SUBJECT: AMENDMENT NO. 170 TO FACILITY OPERATING LICENSE NO. NPF-3  
(TAC NO. M77029)

The Commission has issued Amendment No. 170 to Facility Operating License No. NPF-3 for the Davis-Besse Nuclear Power Station, Unit No. 1. The amendment revises the Technical Specifications in response to your application dated April 12, 1991.

DAVIS-BESSE NUCLEAR POWER STATION, UNIT NO. 1

ATTACHMENT TO LICENSE AMENDMENT NO. 170

DAVIS-BESSE NUCLEAR POWER STATION  
UNRESTRICTED AREA  
BOUNDARY FOR LIQUID EFFLUENTS  
Fig. 5.1-3

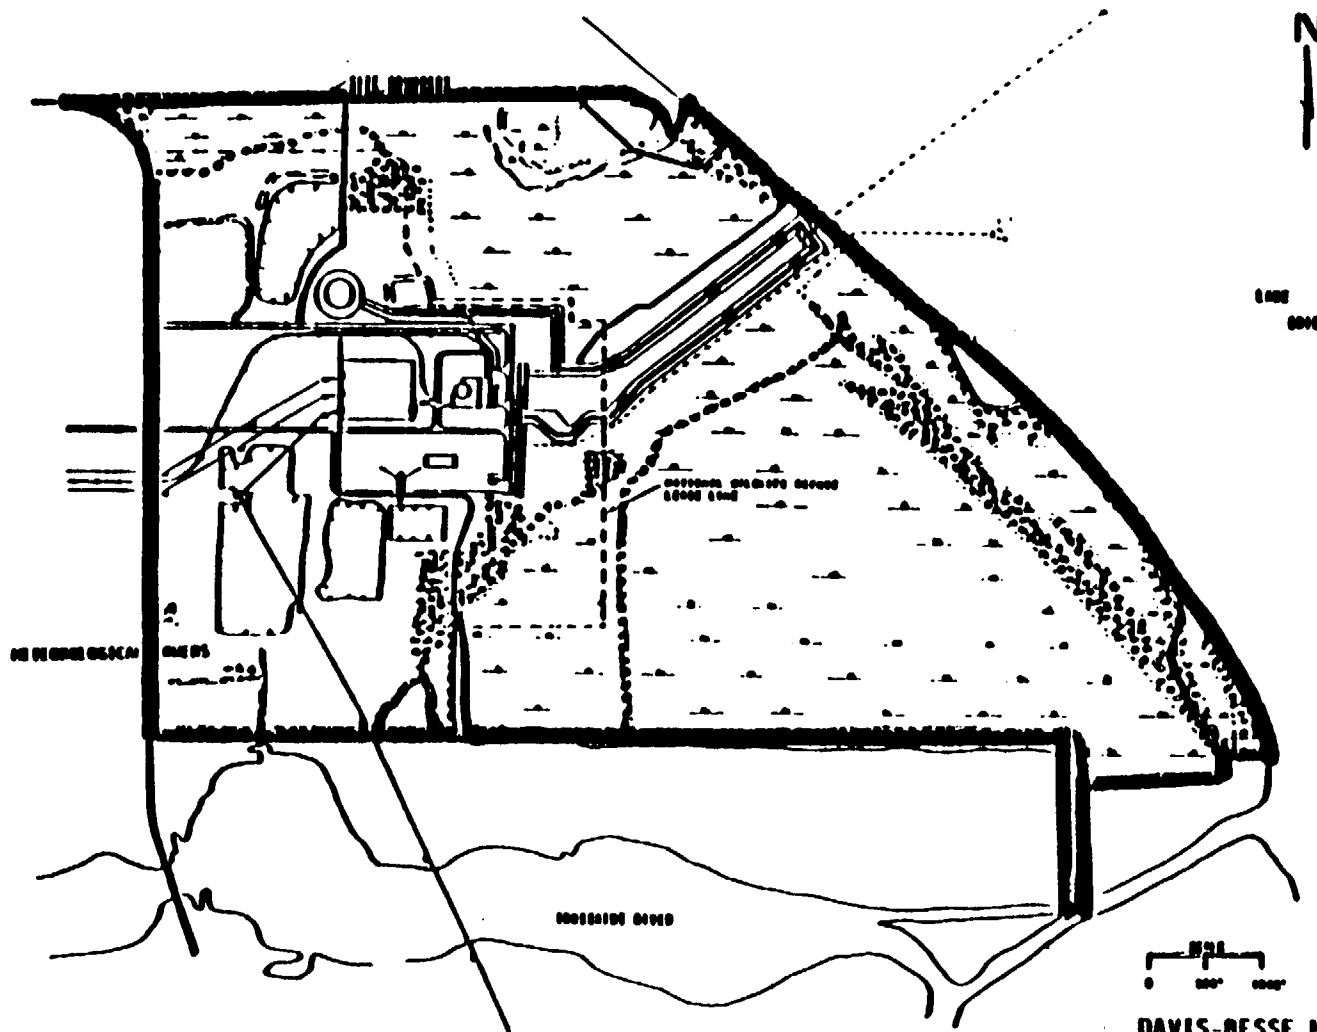
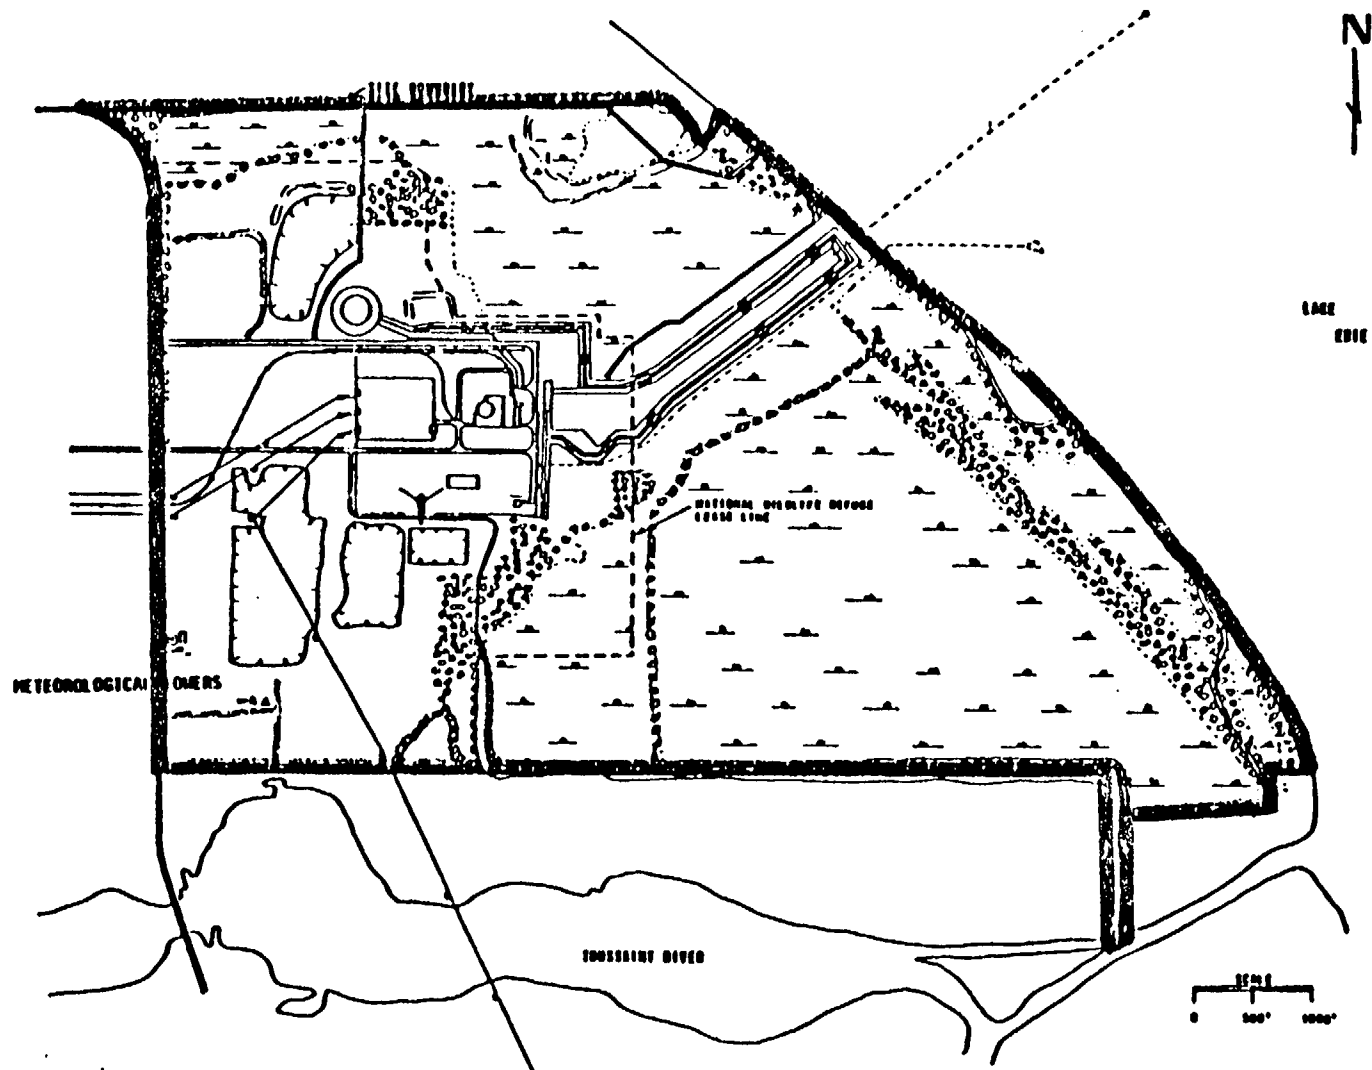
5.1.3 The UNRESTRICTED AREA and SITE BOUNDARY for radioactive liquid effluents is shown on Figure 4.1-3. The UNRESTRICTED AREA and SITE BOUNDARY for radioactive gaseous effluents is shown on Figure 5.1-4.
